CONTINENTAL AEROSPACE TECHNOLOGIES™
CRITICAL SERVICE BULLETIN

CATEGORY 2
CSB23-04

Alert Service Bulletin No. 097

Alternator Mounting Flange Inspection

Figure 1 - Alternator Mounting Flange

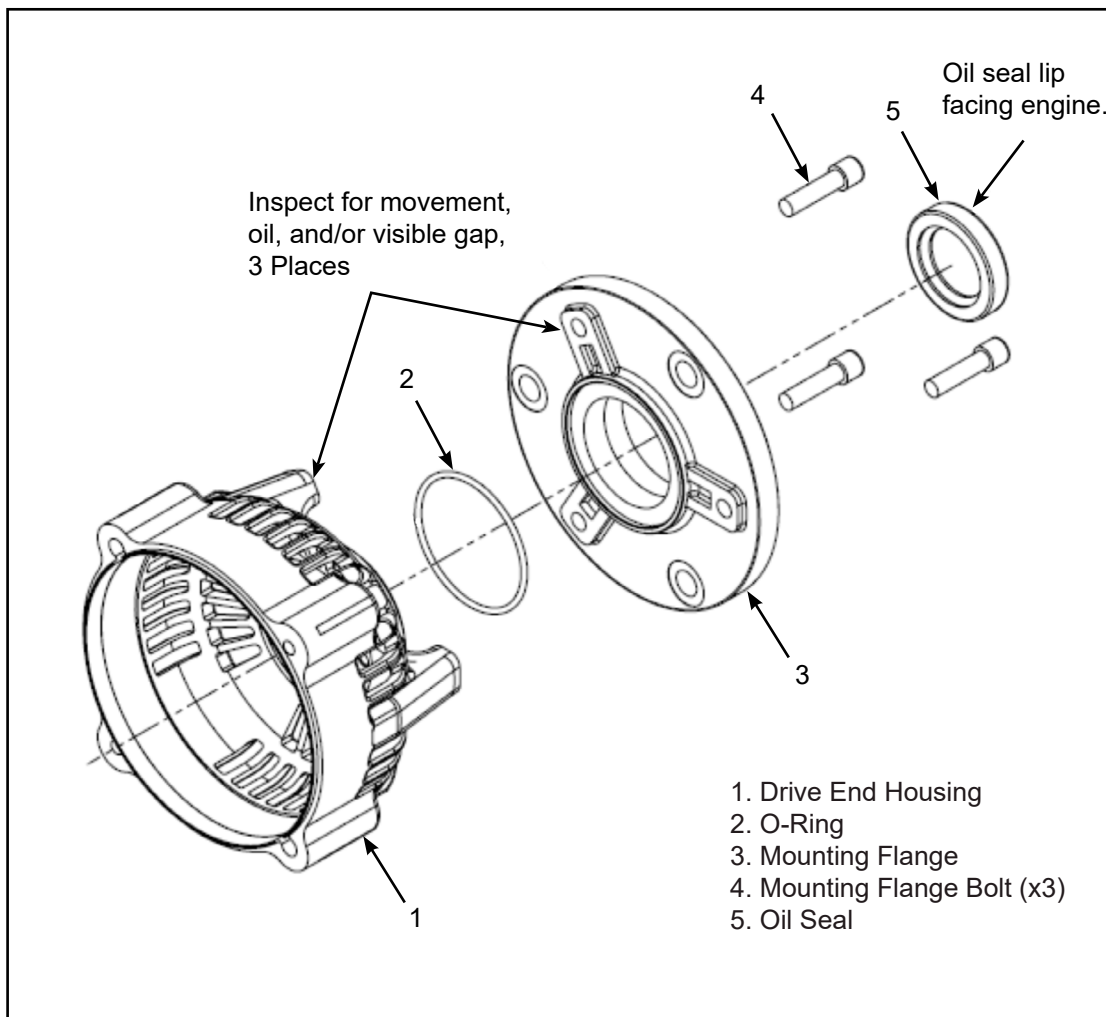
- (1) Hartzell Engine Tech has discovered that alternator P/Ns referenced in 1.A. may experience a reduction in clamping force at the joint between the alternator drive end housing (1) and mounting flange (3).
 - (a) Loss of alternator mounting flange clamping force may result in loss of engine oil and/or unexpected loss of engine power.
- (2) This ASB is to advise the field of a known condition and to supply inspection criteria to identify affected alternators.

- (1) If a loose condition or oil leak is **not** found
 - (a) Remove affected alternator per applicable aircraft engine and airframe service instructions or maintenance manual.
 - (b) Remove and discard one of three flange bolts (4) securing the alternator to the mounting flange.
 - (c) Apply a mild solvent to a non-metallic bristle brush and remove oil/grease and any cured threadlocker present in the drive end housing threads. Ensure debris does not enter the alternator housing.
 - (d) Apply LOCTITE® 272 threadlocker to one of three drive end housing (1) threads and install one new flange bolt (4) to snug condition.
 - (e) Repeat steps (b) thru (d) for remaining two flange bolts.

- (f) Torque alternator mounting flange bolts to 85-90 in-lbs.
 - (g) Inspect alternator drive coupling per manufacturer's instructions.
 - (h) Install the alternator onto the engine per applicable aircraft engine and airframe service instructions or maintenance manual. Continue to 3.C, Return to Service.

- (m) Install the alternator mounting flange (3) onto the alternator drive end housing (1). Secure with three new mounting flange bolts (4) to snug condition.

- (n) Torque alternator mounting flange bolts (4) to 85-90 in-lbs.
 - (o) Reinstall the alternator drive coupling onto the alternator and perform any required inspections per manufacturer's instructions.

Figure 2 - Oil Seal Push Tool

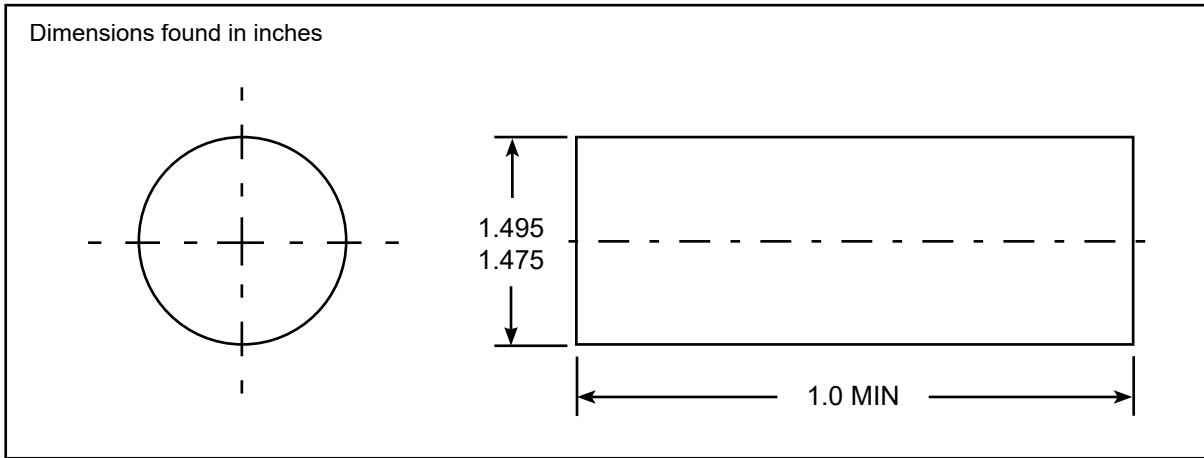
- (d) Inspect the mounting flange (3) for damage, replace as required.
 - (e) Using an arbor press and adequate push tool, push the oil seal (5) from the mounting flange (3) and discard the oil seal. Manufacture push tool per dimensions in **Figure 2**.

Figure 3 - Oil Seal Orientation

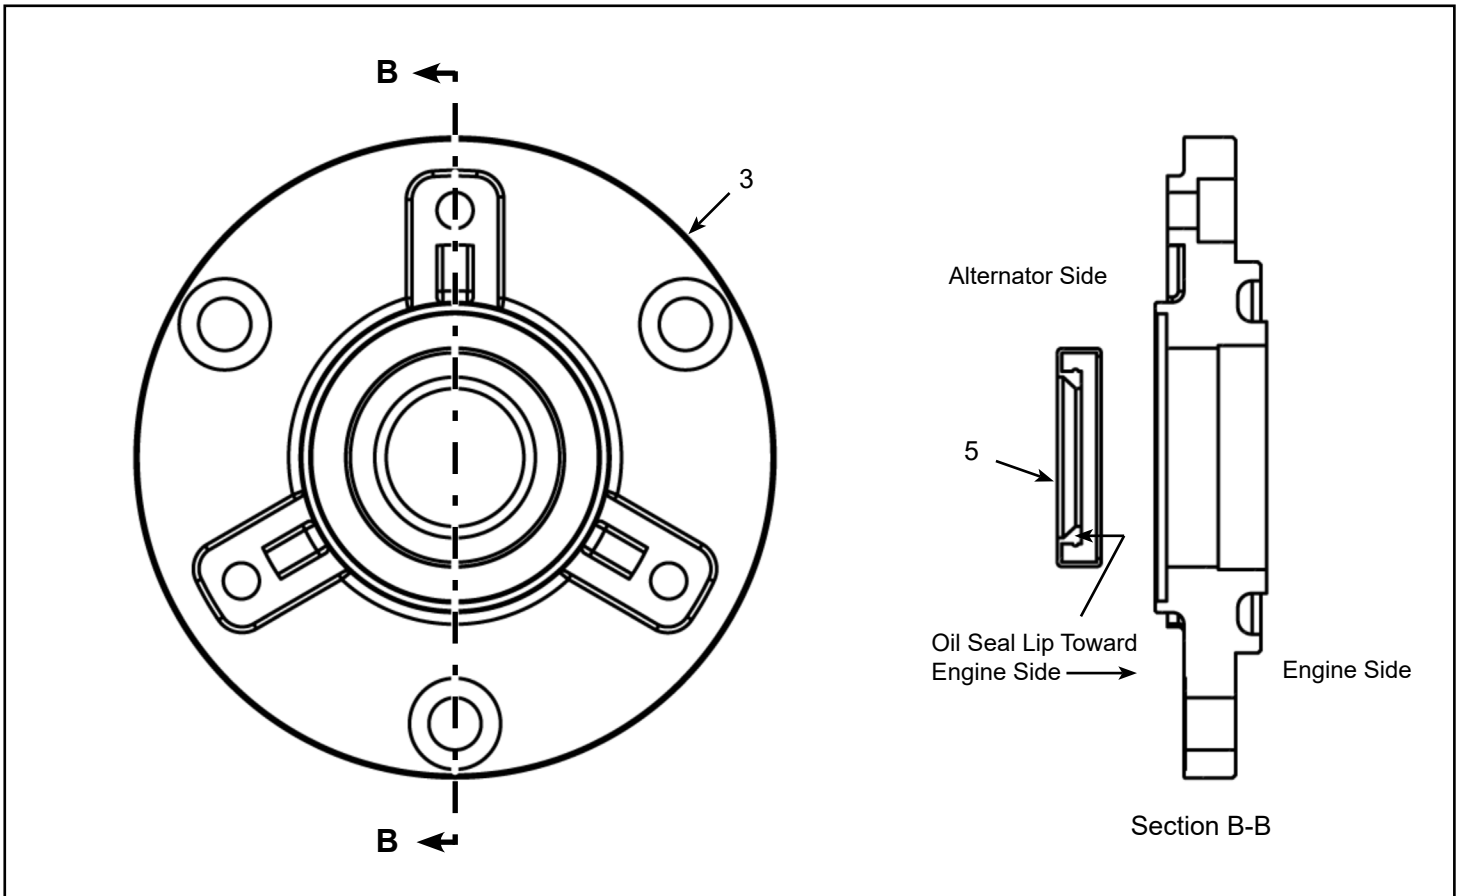
- NOTE:** Push the oil seal from the engine side of the mounting flange (3). See **Figure 3**.
- (f) Clean oil seal bore of mounting flange with mild solvent and non-metallic bristle brush and shop towel. Dry with shop air.

- (g) Using an arbor press and adequate push tool, press new oil seal (5) from alternator side of the mounting flange (3) with oil seal (5) lip facing down (toward engine). Press flush to .015 in. below flush with oil seal bore. See **Figure 3**, Oil Seal Orientation.
